ADDENDUM NO. ONE (1)
CITY OF STATHAM, GEORGIA
OAK STREET SPRING IMPROVEMENTS
ISSUED March 27, 2026

RE: OAK STREET SPRING IMPROVEMENTS
EMI PROJECT No. 24-012

This Addendum forms a part of the Contract Documents and Drawings and modifies the original bidding documents dated FEBRUARY 2026.

M1

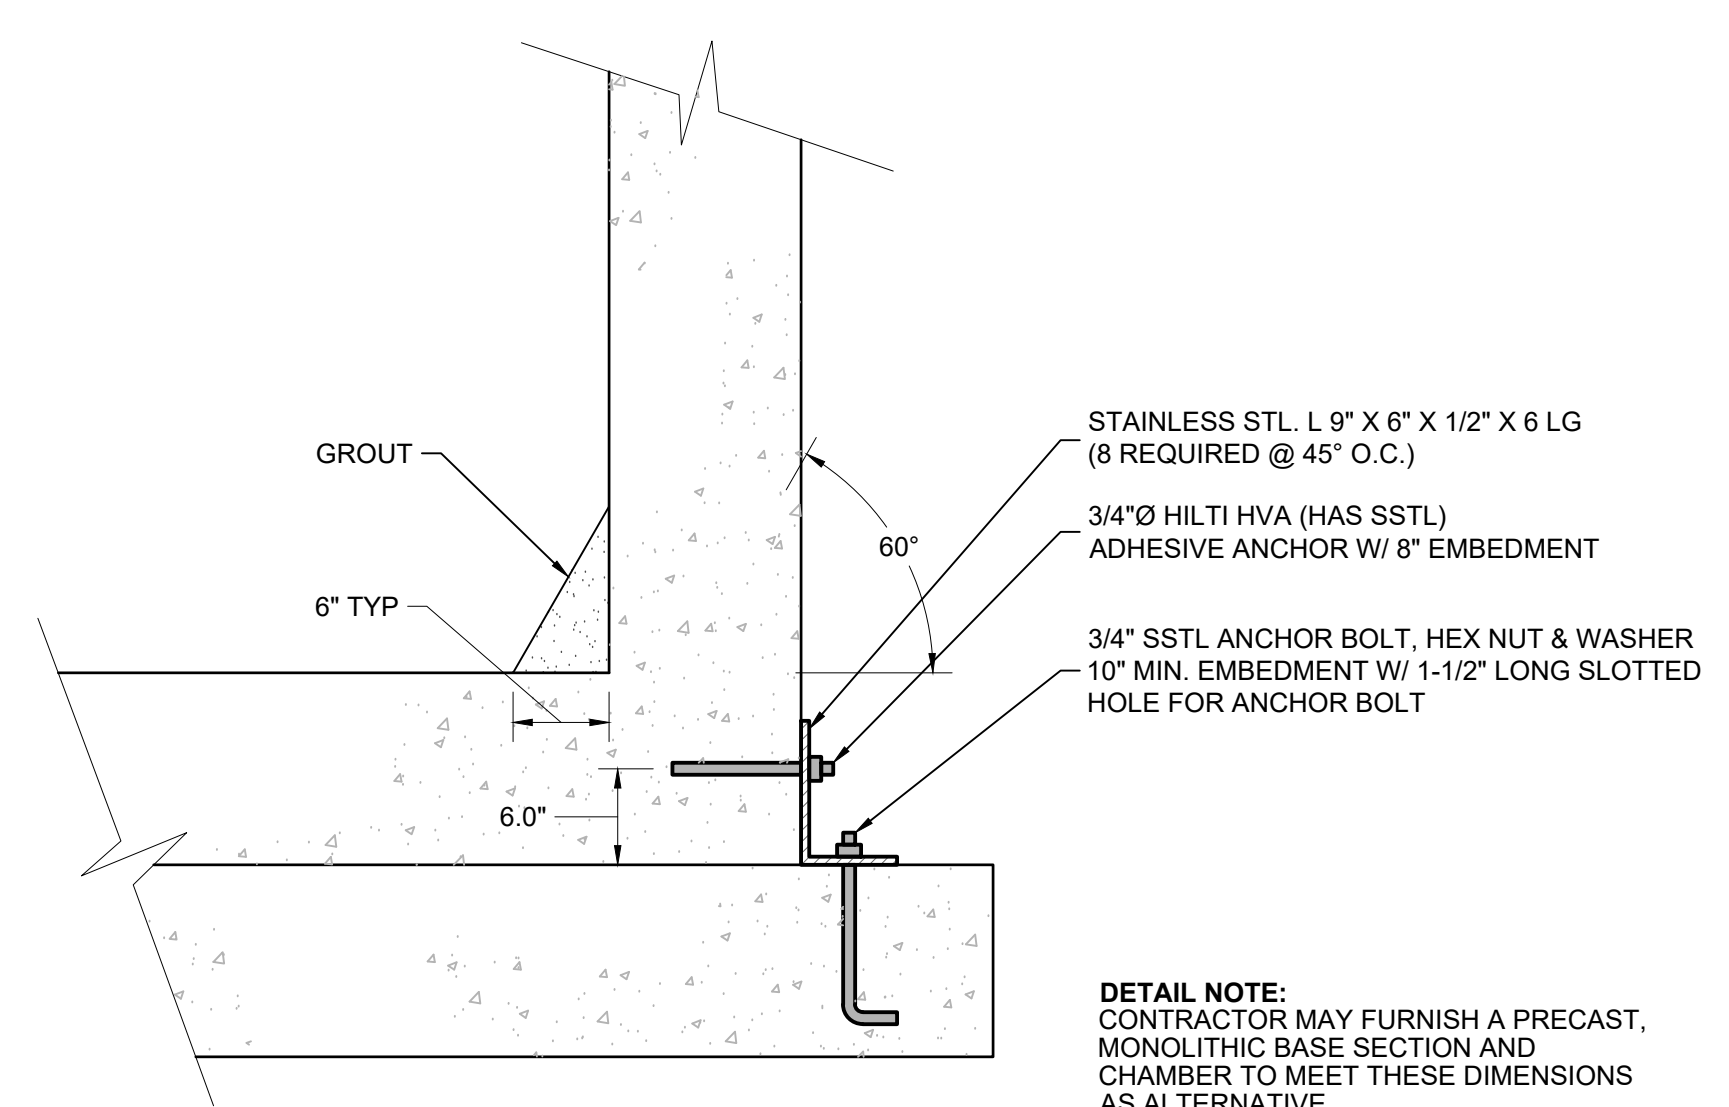
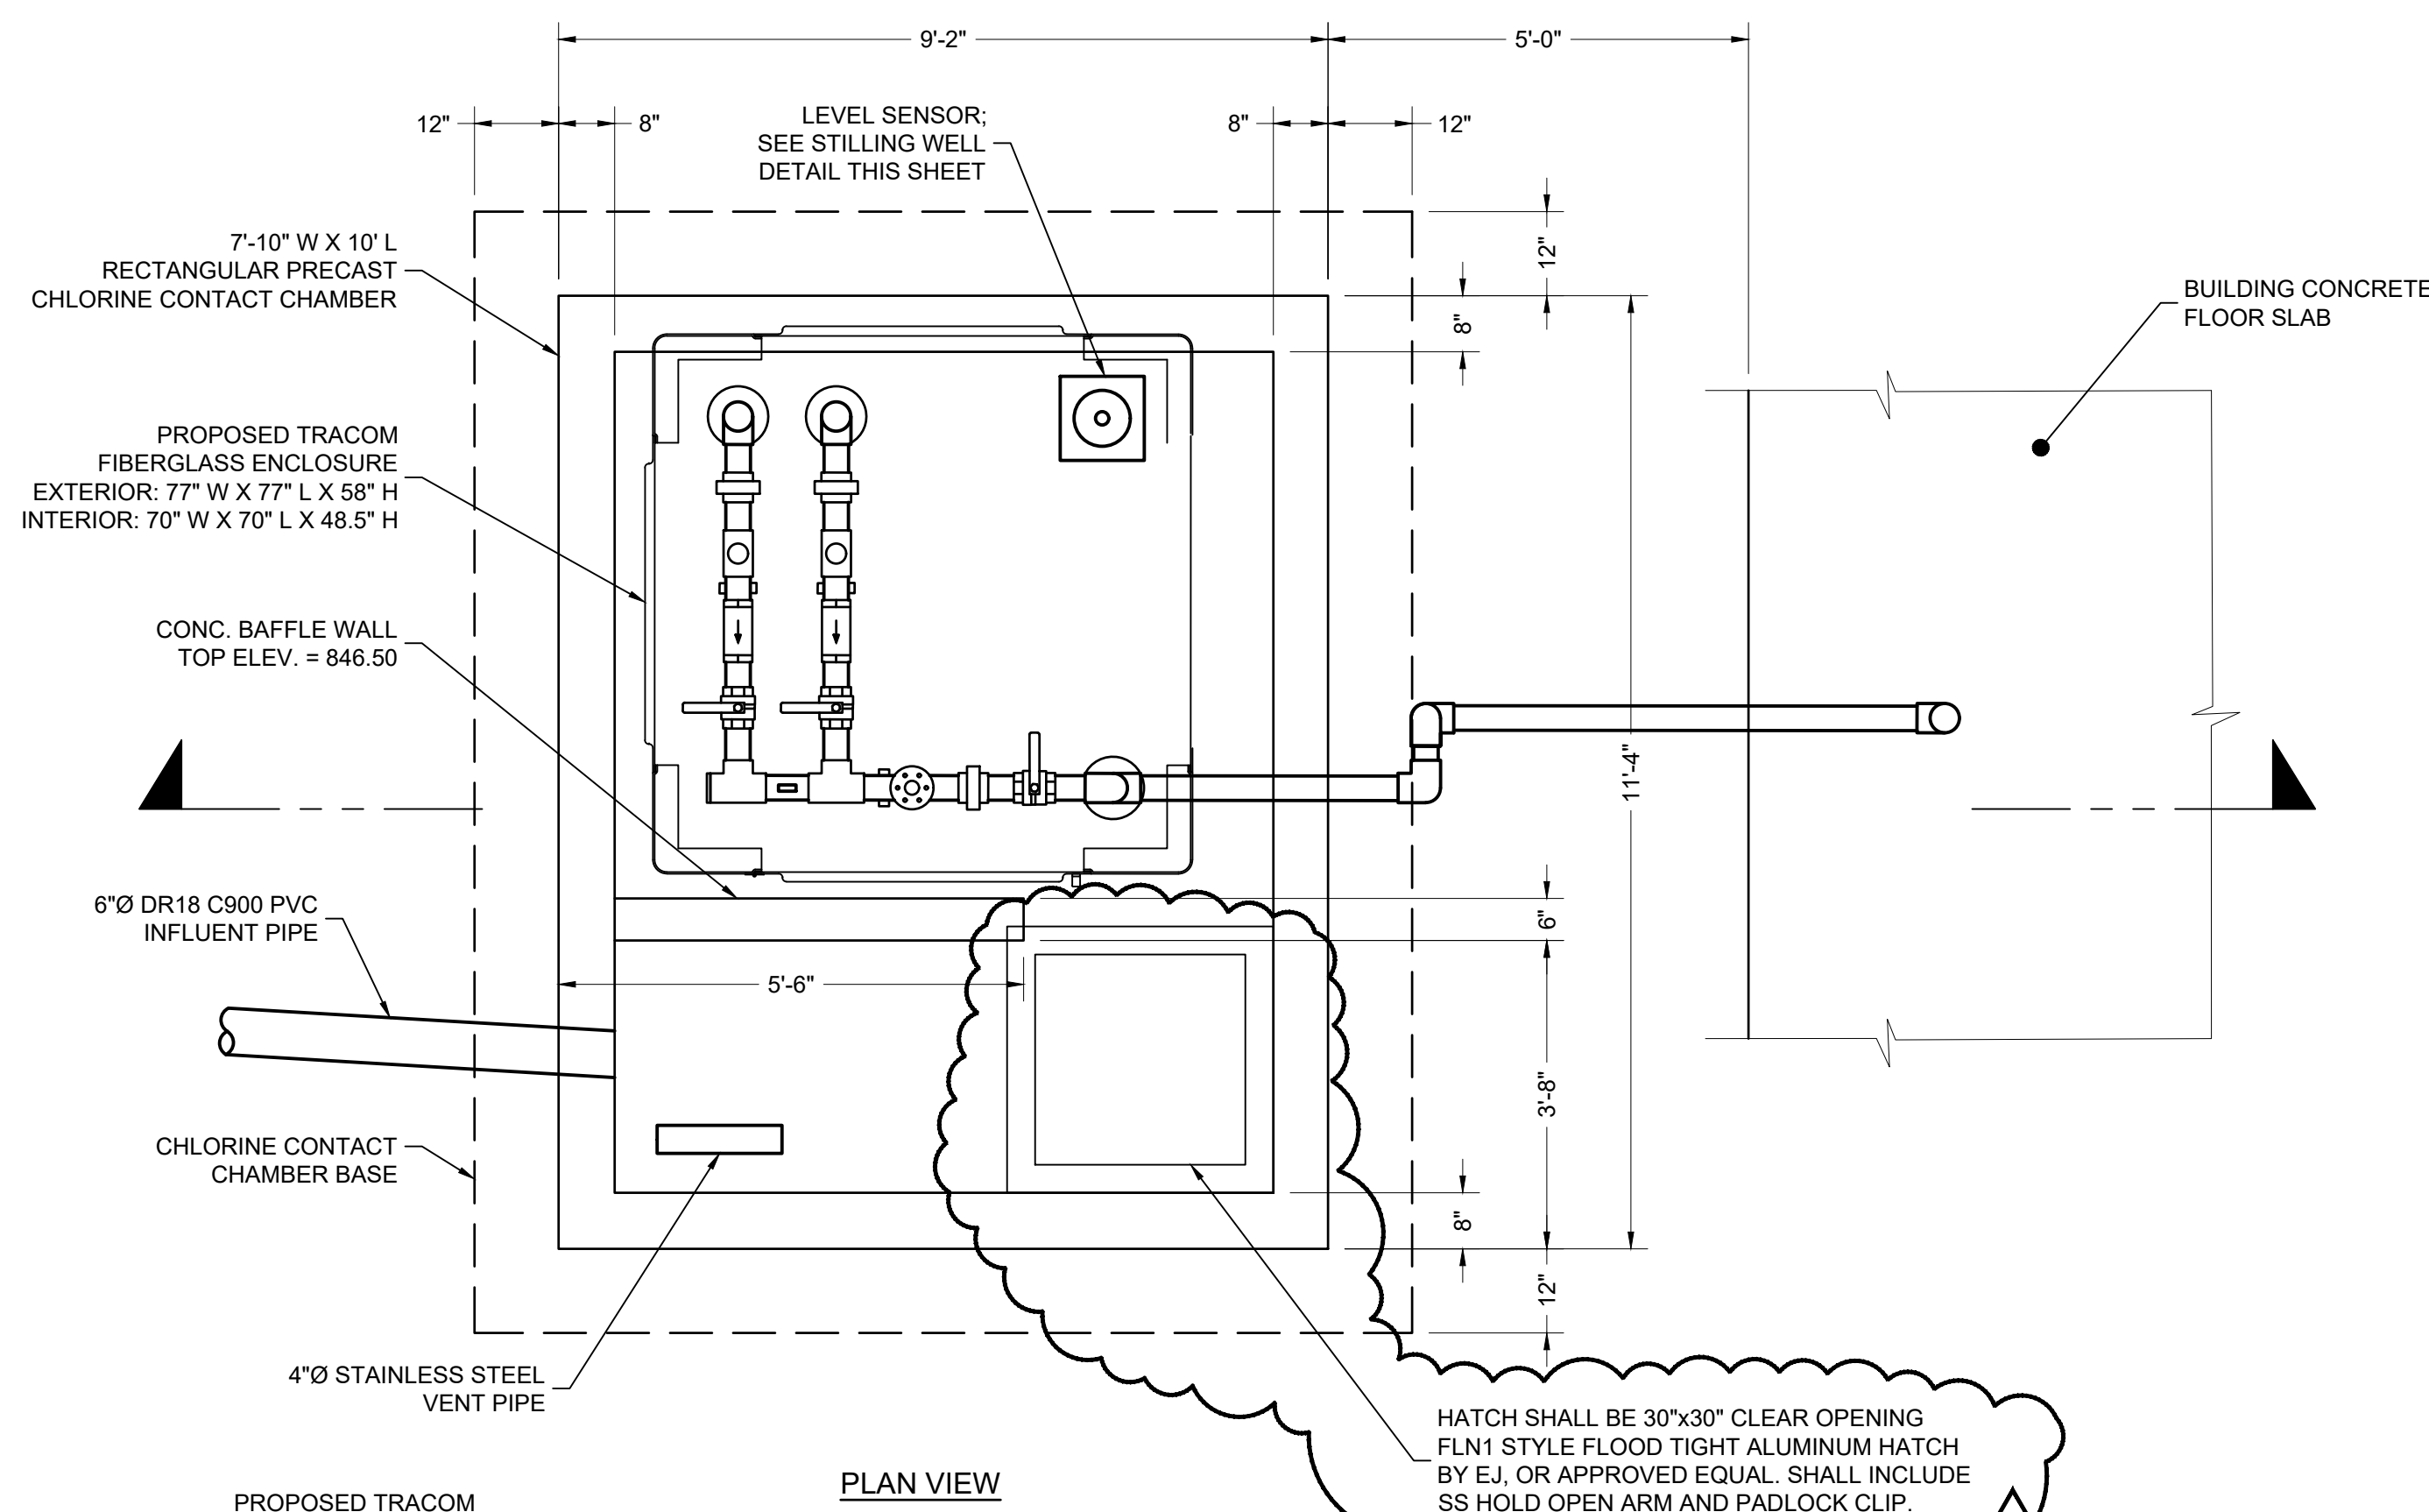
- Plan sheet M1 has been revised as follows. See attached revised plan sheet. (revisions are shown with revision clouds)
 - **Ball valves have been added to the horizontal above ground pipes from the pumps just after the check valves.**
 - **The clearwell hatch has been changed to 30"x30".**
 - **The 1.5inch meter has been changed to a 2inch Neptune Tru/Flo compound meter to match the City's existing meter system.**

14. 3"Ø BALL VALVE - NIBCO PVC SCHEDULE 80 MODEL C, RATED FOR 150 PSI, NSF61

27. 2" NEPTUNE TRUI/FLO COMPOUND WATER METER WITH 4-20ma SIGNAL TO CONNECT TO SCADA (SEE SHEET E1). CONTRACTOR TO PROVIDE FITTING TO REDUCE PIPE SIZE AS NECESSARY IN ORDER TO CONNECT METER.
